DS-K1T680 Series MinMoe Terminal Release Note

(2022-01-26)

Device Model: DS-K1T680D(F)-E1 DS-K1T680D(F)W DS-K1T680D(F)G DS-K1T680D(F)G1 Naming Rule: D for M1 card, Desfire card, Felica card E1 for POE, W for Wi-Fi, F for fingerprint G1 for 3/4G, supported in Australia, Taiwan (China) and Latin America; G for 3/4G, supported in Europe, the Middle East, Africa, India, and Most Areas of Asia-Pacific (excluding Japan and Taiwan (China))	Firmware Version	ARM : ACS_680_AI3_EN_ STD _V3.2.35_build2 20114 ACS_680_AI3_EN_ NEU _V3.2.35_build2 20114
	SDK	Latest version
	iVMS-4200 Version	Latest version

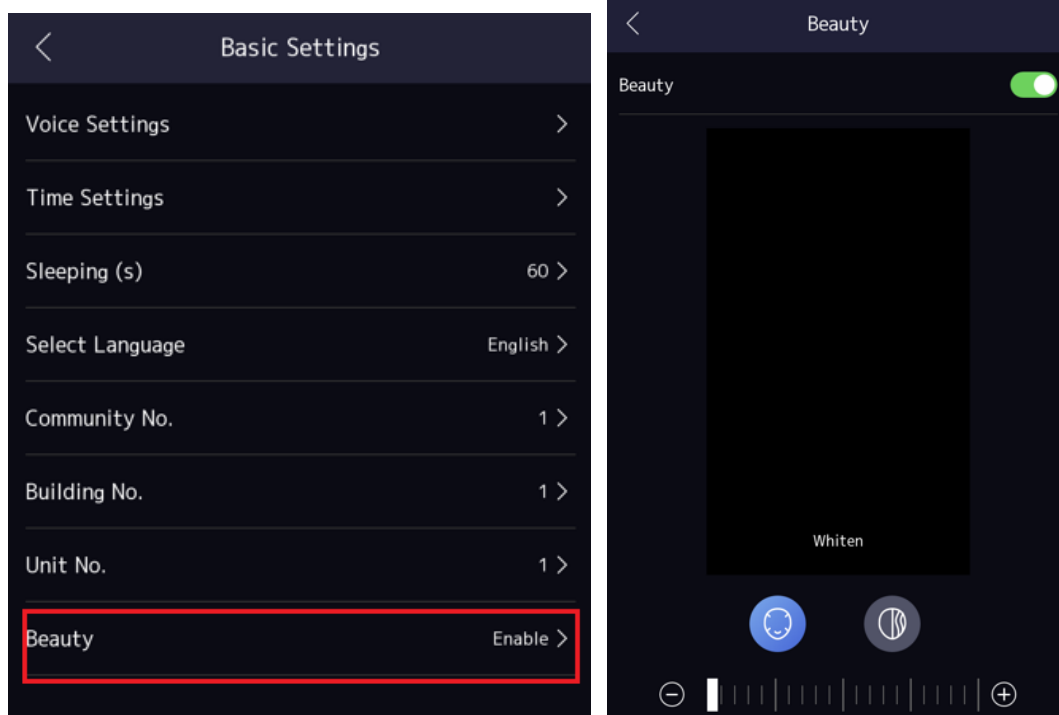
1. Support **advertisement mode**: upload pictures from web and always display on the screen, recommend using company logo or advertisement picture.

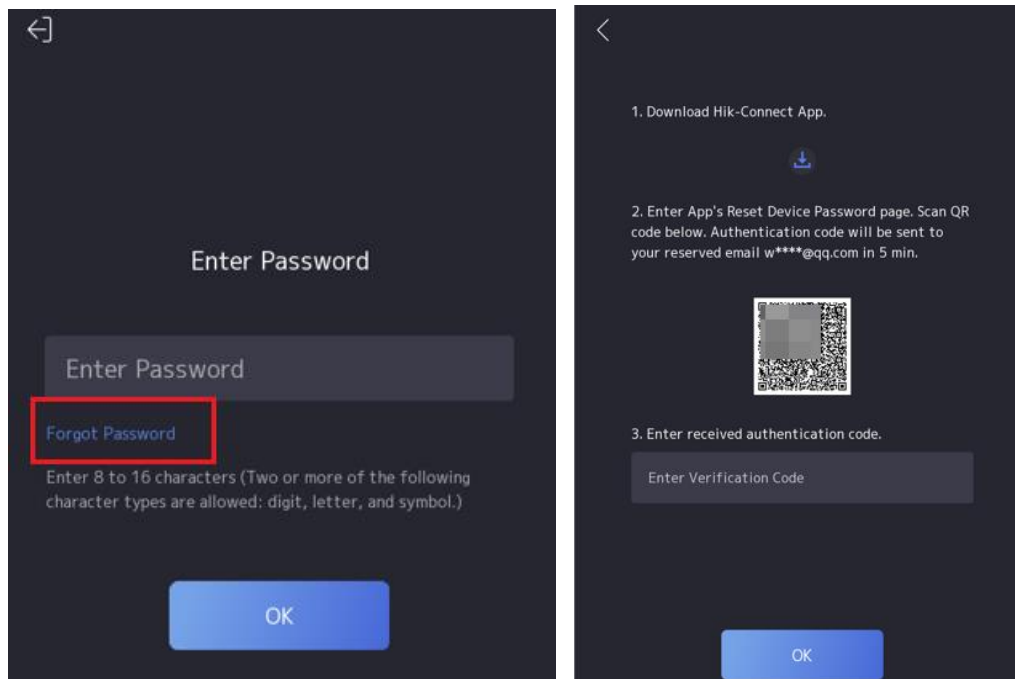
2. Support beauty function

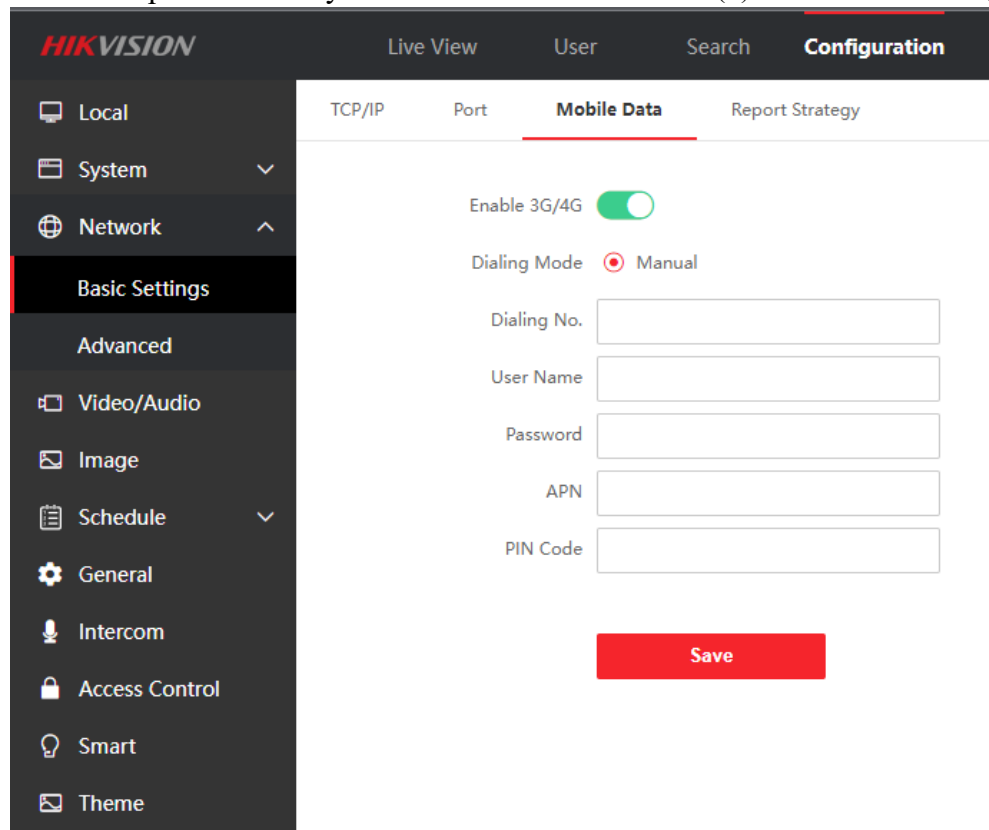
- Support APN configuration.

Note: The parameter only work for model DS-K1T680D(F)G and DS-K1T680D(F)G1

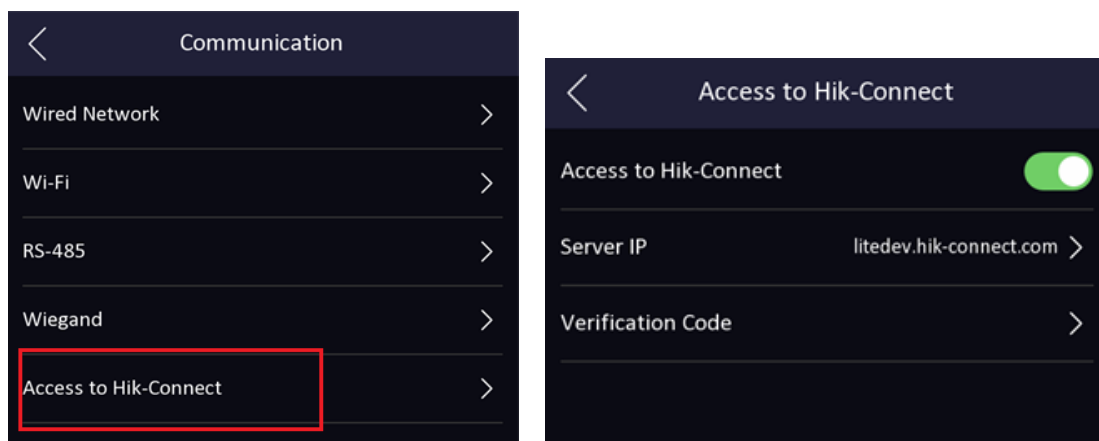
1. Add Hik-Connect menu in device UI Menu → Comm. The function is disabled in default.

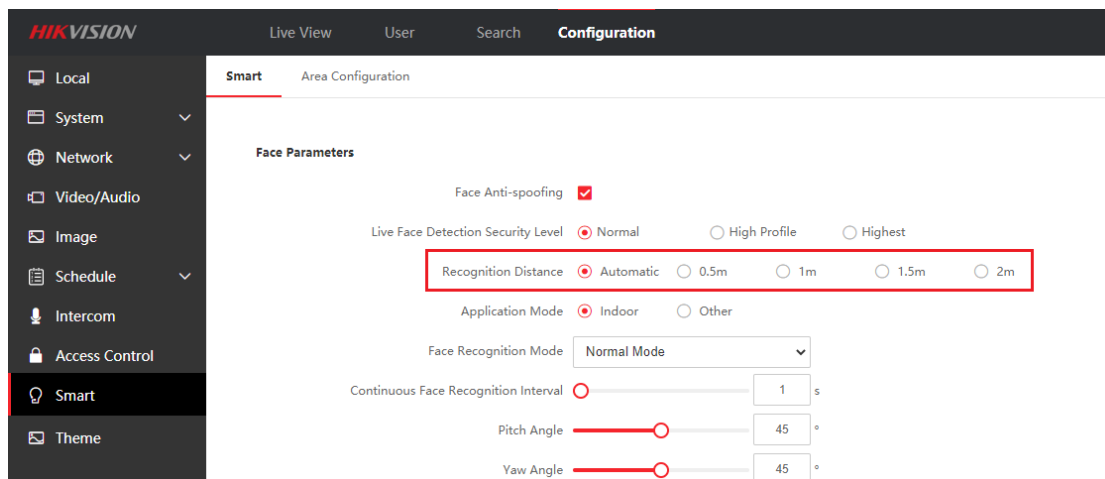
1. Optimize the wake-up distance of the device screen through the face, and the wake-up distance is consistent with the recognition distance

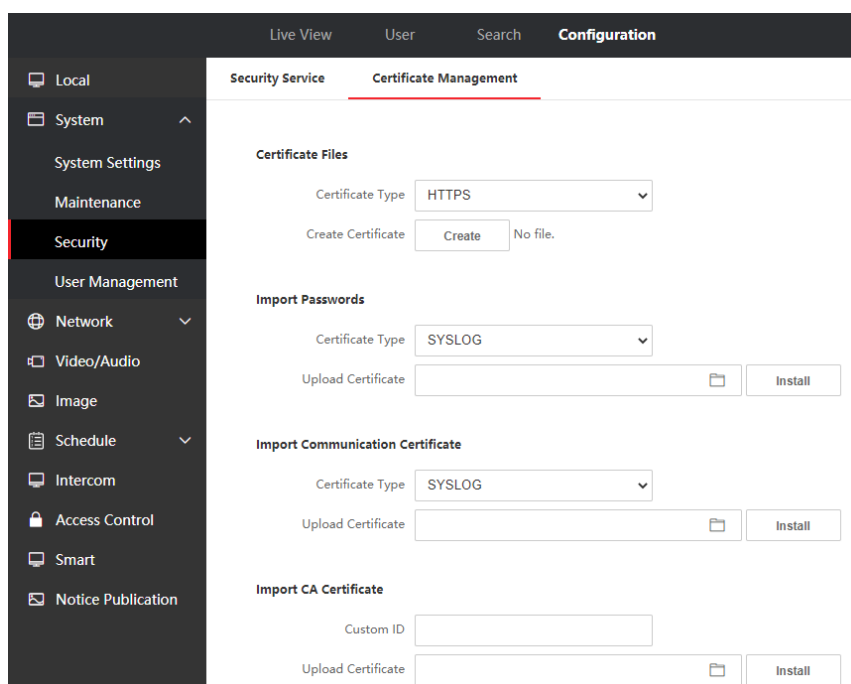
1. Support https feature

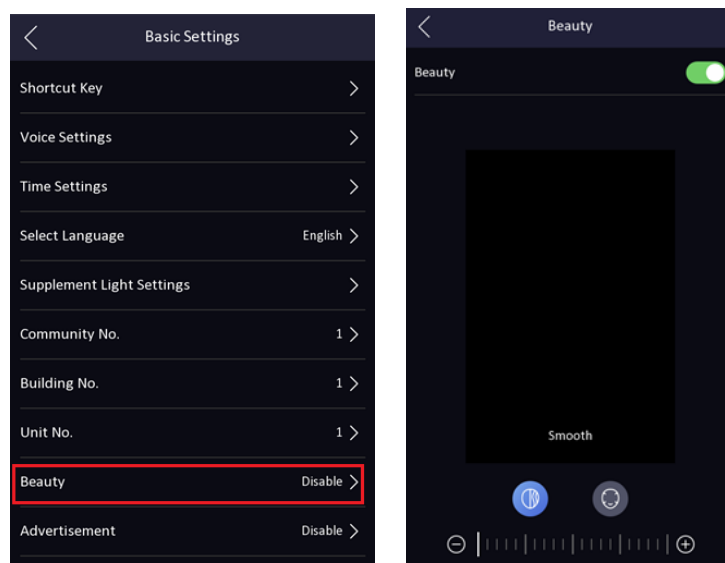
2. Support Hik-ProConnect platform docking

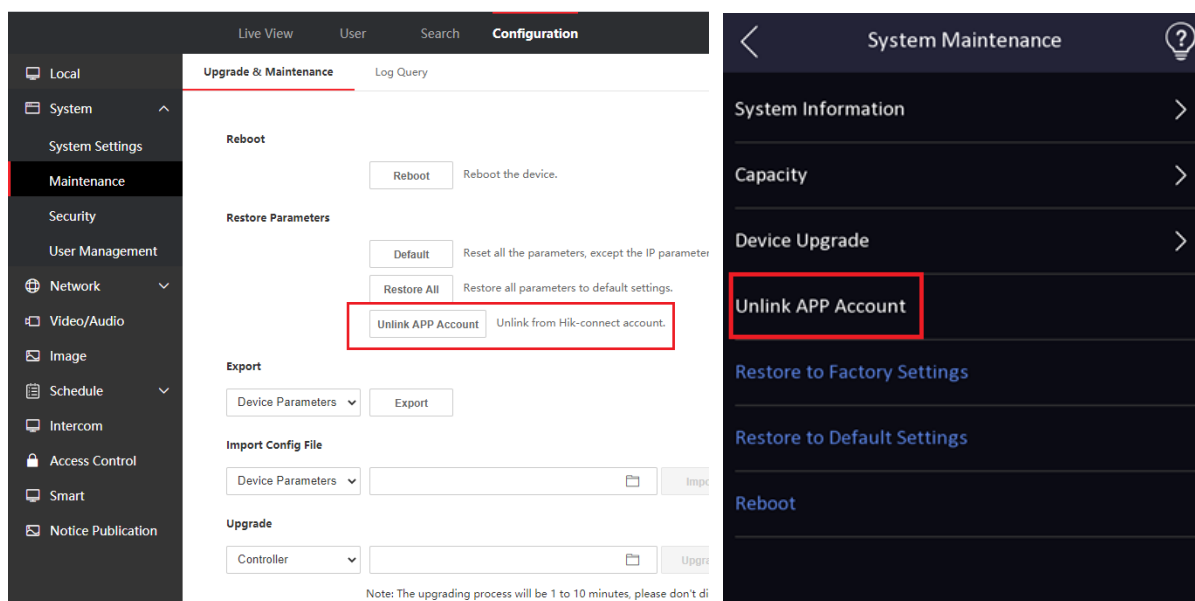
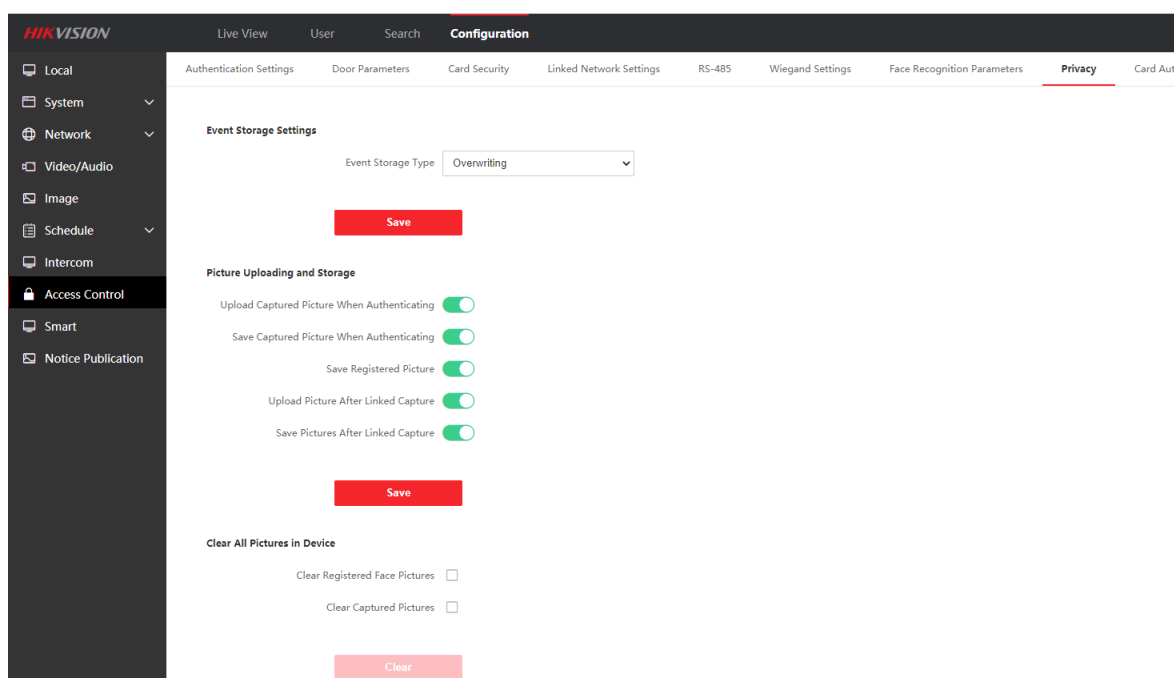
6. Support unbind device with hik-connect account on SADP tool, local UI and web

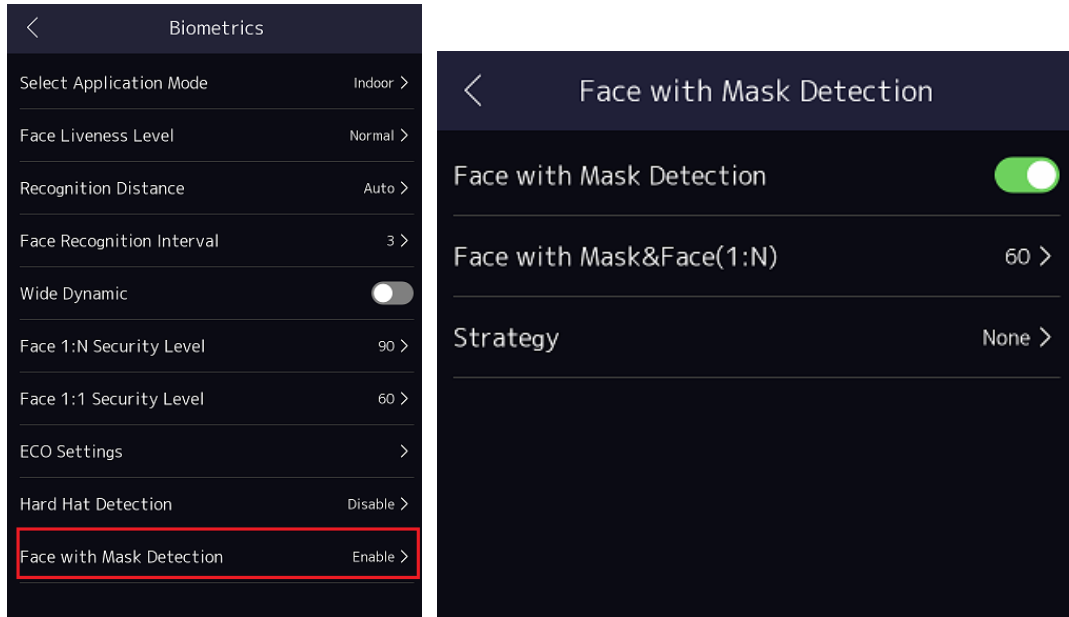
7. Add privacy protection, support event Storage Settings, Picture Uploading and Storage, Clear All Pictures in Device

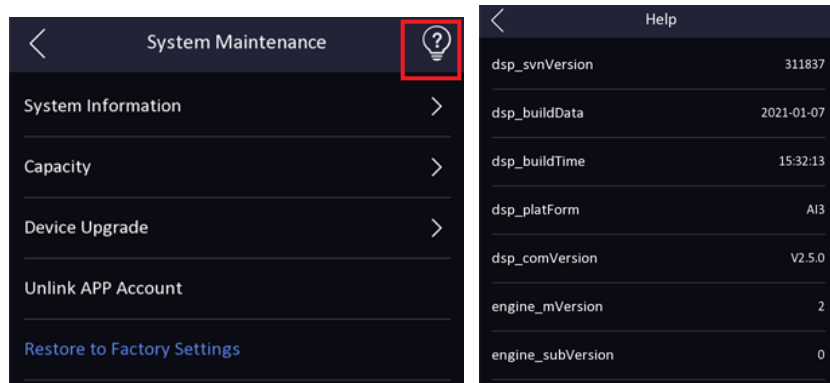
8. Add face mask detection function(enabled in default);

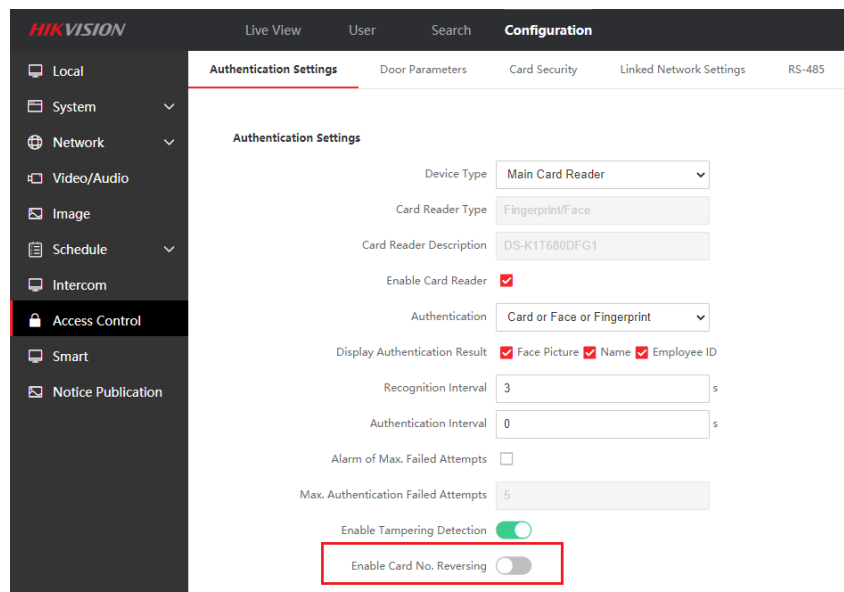
9. Add help interface to check system module version for technical support (long press for 3s).

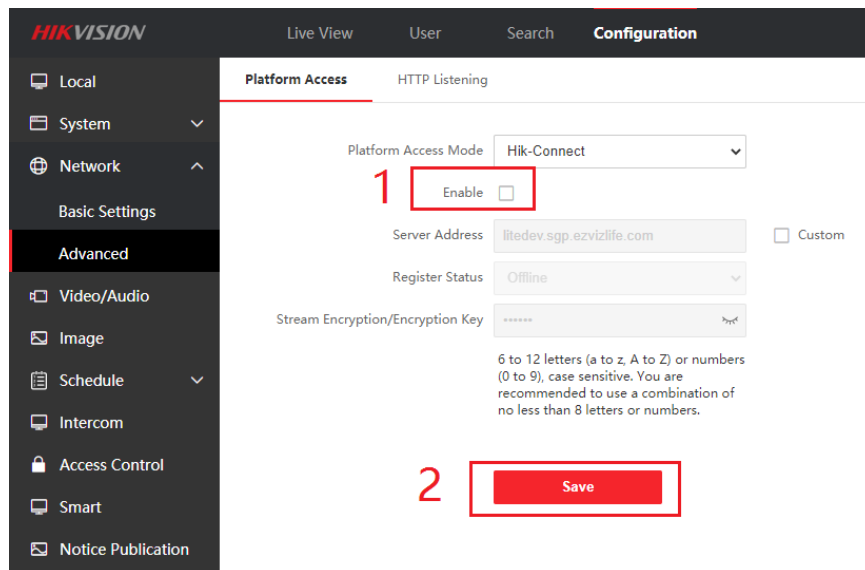
10. Add card No. reversing function (external reader not support)

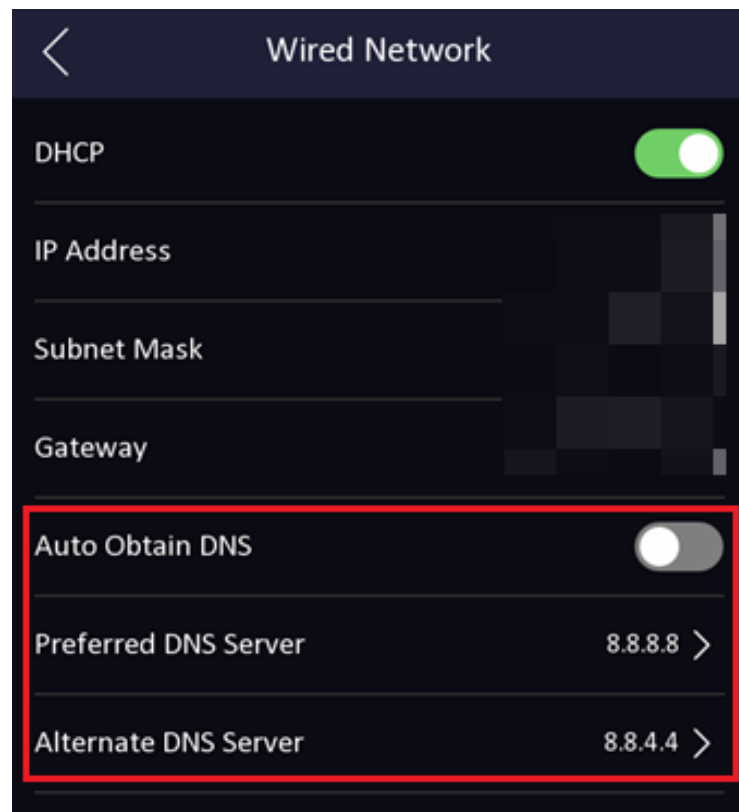
- Hik-Connect function is turned off in default for privacy protection, if customer want to manage device from App, please turn on manually in the web.

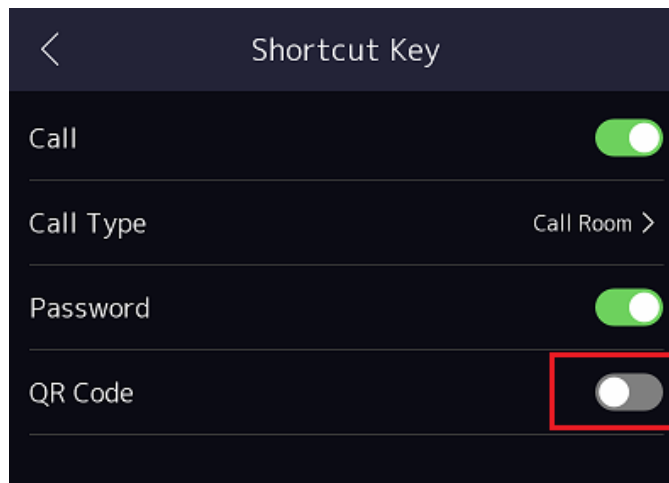
- DNS can be configured from device UI in menu → Comm.-->Wired Network

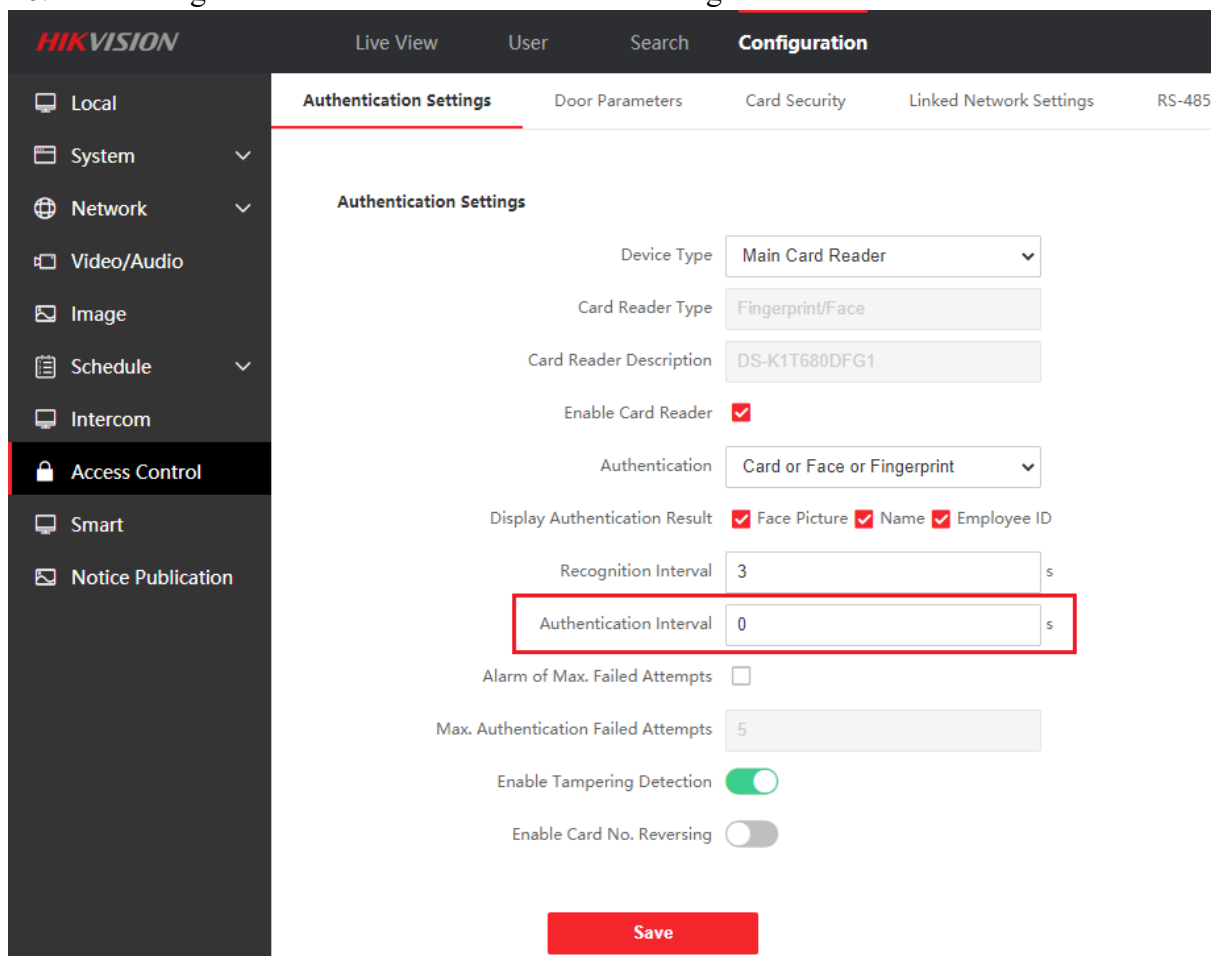
- After disable QR code shortcut from the menu, device will support QR code and face verification at the same time.
